**Five-Year Review for
Naval Reactors Facility
Operable Unit 8-05/06 Inactive Landfill Areas
and
Operable Unit 8-08 Remedial Action Sites**

December 2006

Re: EPA Concurrence with the Five-Year Review for the Naval Reactors Facility, Operable Unit 8-05/6 Inactive Landfill Areas and Operable Unit 8-08 Remedial Action Sites

Figure 3-4 Top of Aquifer March 2006

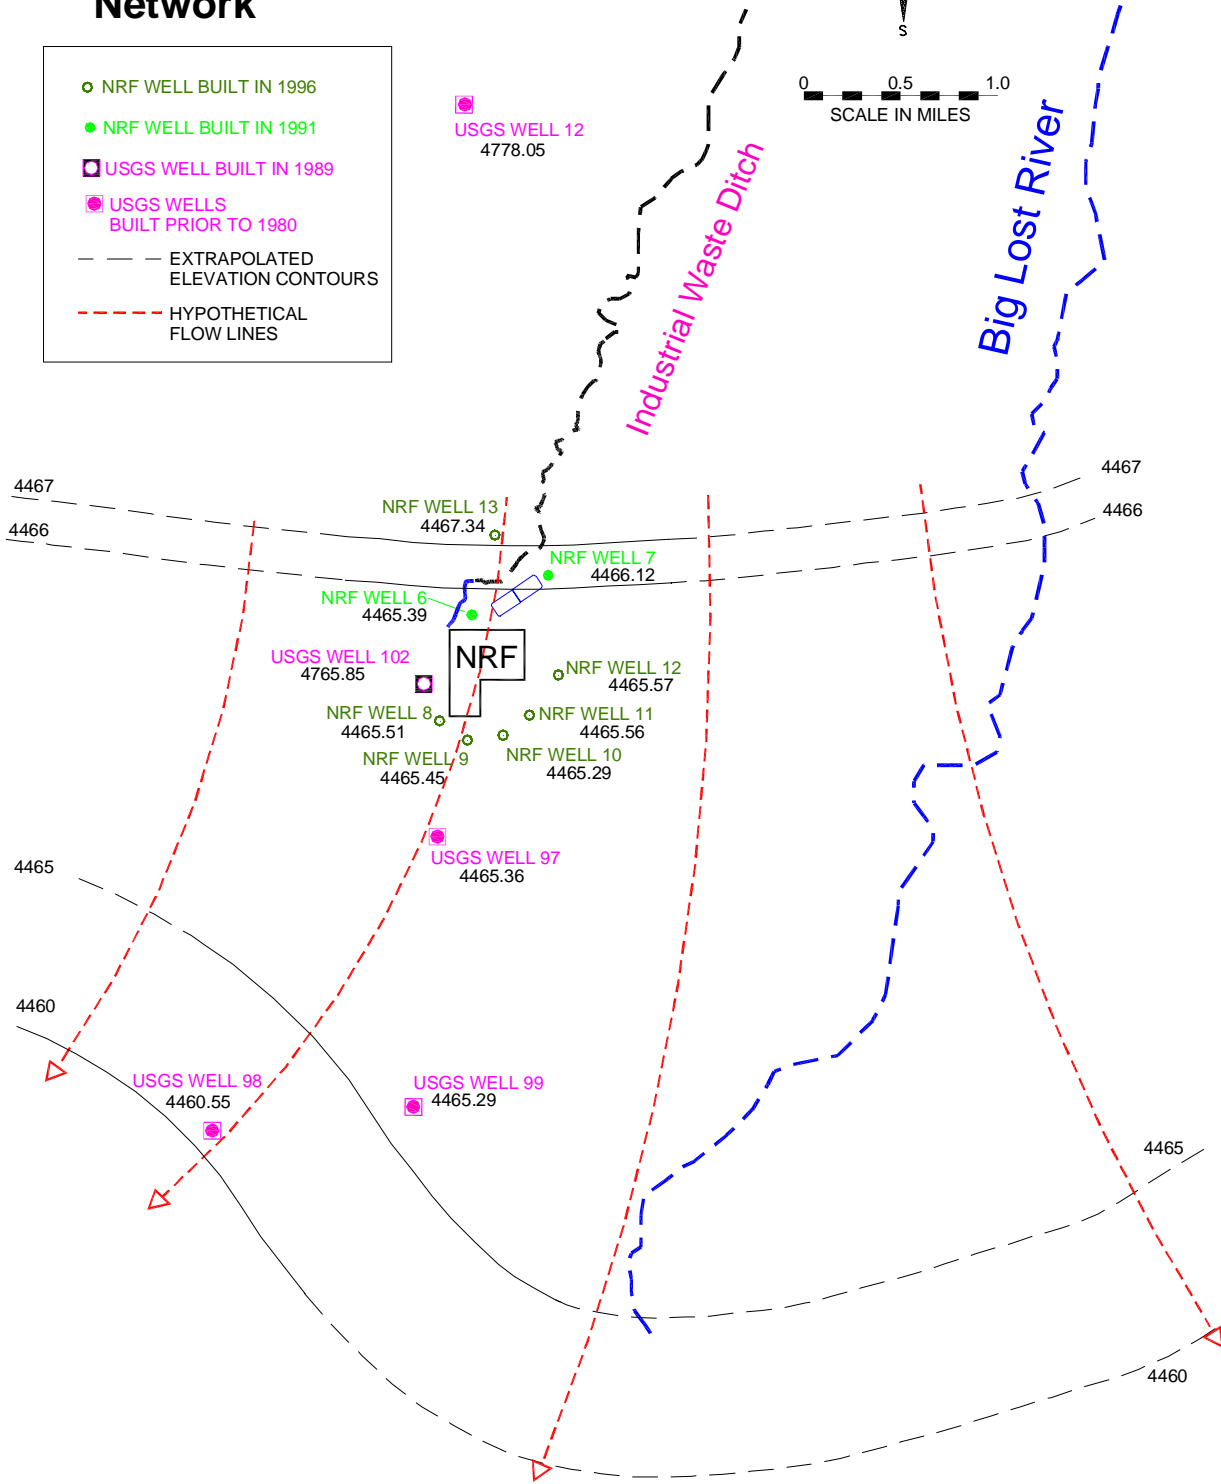
1) Section 3.2.2.1, paragraph 3, page 11 and Figure 3-4, page 12

Figure 3-4 is based only on NRF data. The second to last sentence of the third paragraph in Section 3.2.2.1 was changed to read: "Figure 3-4 is a map showing the top of the aquifer near NRF during March 2006 *based on water table elevation data collected from NRF wells.*"

Figure 4-4 NRF-12B/14, NRF-21A, and NRF-19 OU 8-08 Engineered Cover Areas

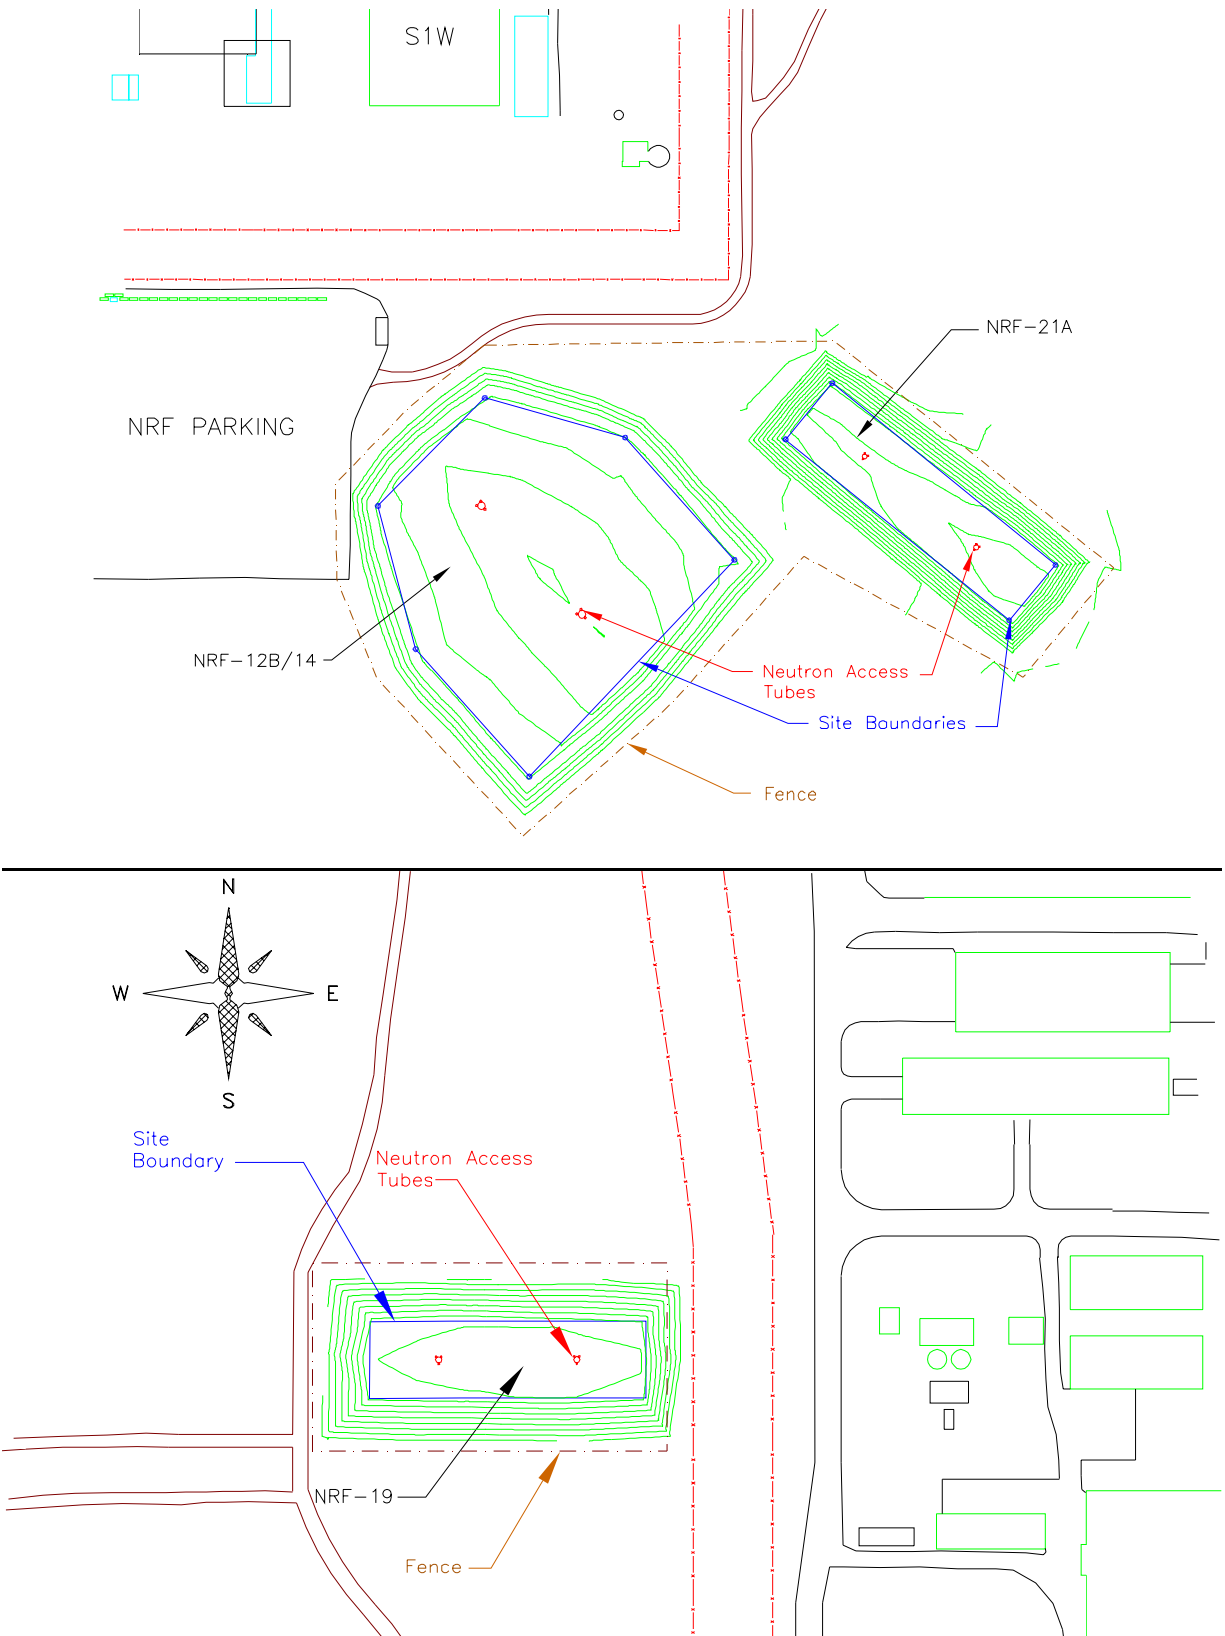
Please add a north arrow to Figure 4-4.

A north arrow was added to Figure 4-4.

Figure 5 Comparison of Metal Concentrations to Turbidity in NRF-13

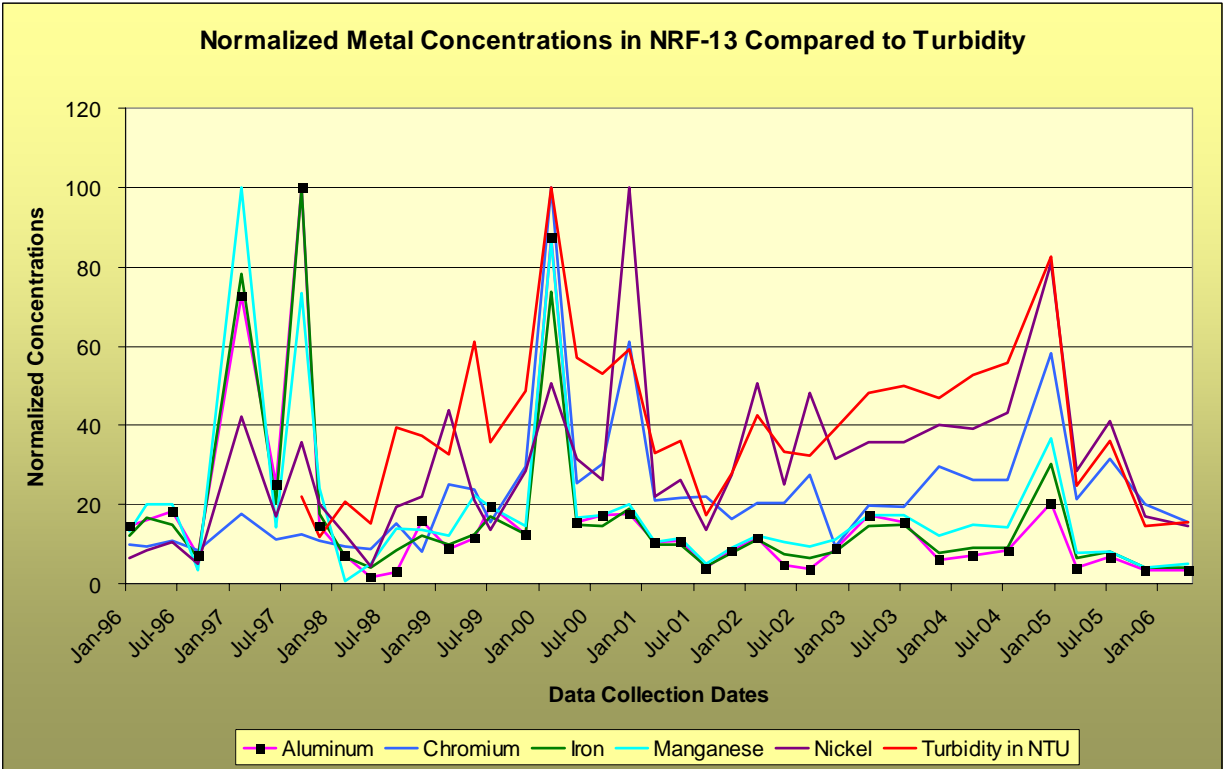
7) Appendix A, section 5.2, Figure 5, page A-16

The Y-axis description of Figure 5 has been changed to be consistent with similar Appendix A figures.

Figure 19 Water Table Elevation at NRF-6, NRF-7, NRF-13, and USGS-12

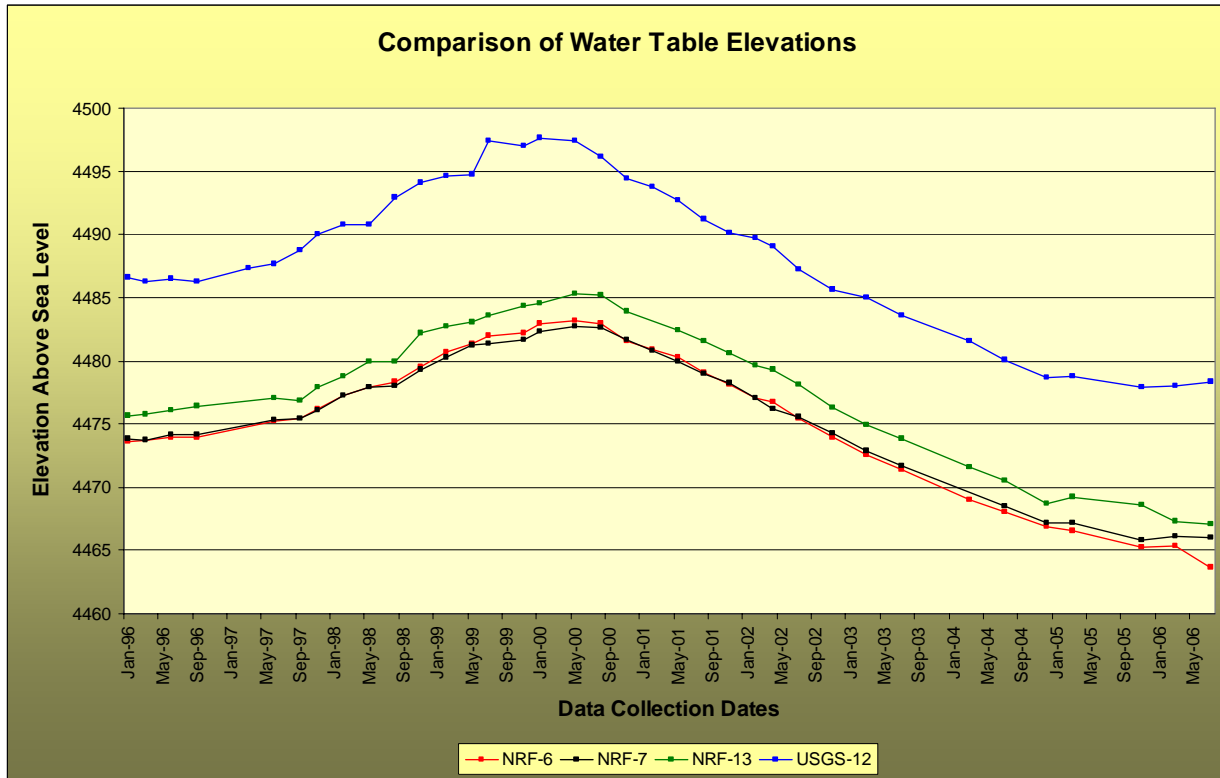
10) Appendix A, section 6.2.3, last paragraph on page A-36 and Figure 19, page A-38
